UNITED STATES PATENT AND TRADEMARK OFFICE

10/802,890

John K. Junkers

DETAILED ACTION

PATENTED APR 24 1973

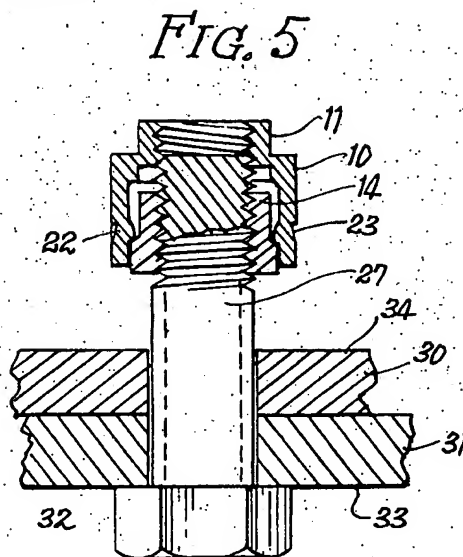
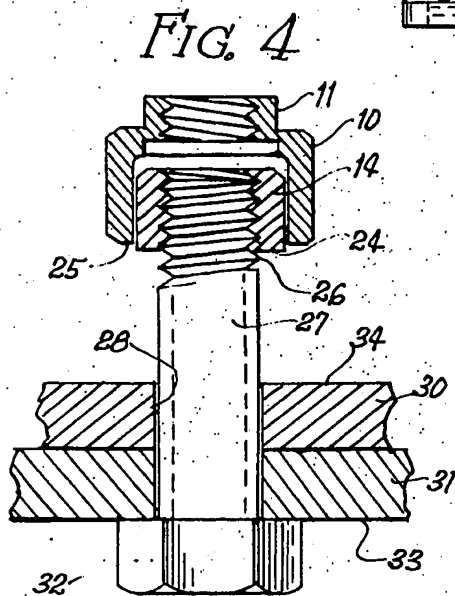
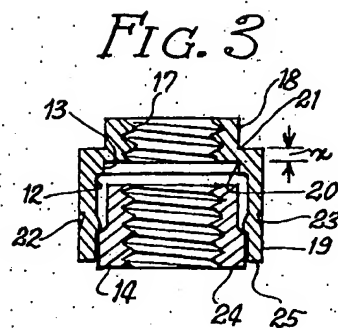
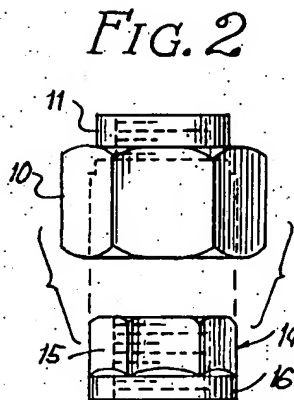
Grube teaches a washer with a body having an axis and first and second axial outer facial surfaces. Further, the washer has an additional turning resistant surface adapted to cooperate with a bolt, said additional turning resistant surface providing friction between the body and bolt to impede the bolt from turning and allowing the bolt to be axially displaced when the nut is turned (abstract Figs 4-7, col 3 line 59 - col 5 line 58). Grube Figs 4-7 teach the assembly of a washer in combination with the bolt.

Fig 4-7 show the turning resistant surface connectable with a bolt thread.

Fig. 4-7 show the body movable in the axial direction, and with one portion provided with said additional turning resistant surface and another portion frictionally connected to said one portion and provided with said second face surface which is adapted to frictionally cooperate with the object (at 24/25).

A breaking point is shown in Figs 6-7, which when broken when the bolt is turned, elongates the bolt in the axial direction.

First, examiner notes that claims 1-8 do not include the bolt or nut, and the washer stands alone, and thus either face can be considered the first or second face of the washer and either part 11, part 14, or the combination can be considered the washer. It is possible to add another lock nut onto the protruding shaft end 27, which is all the claims require.
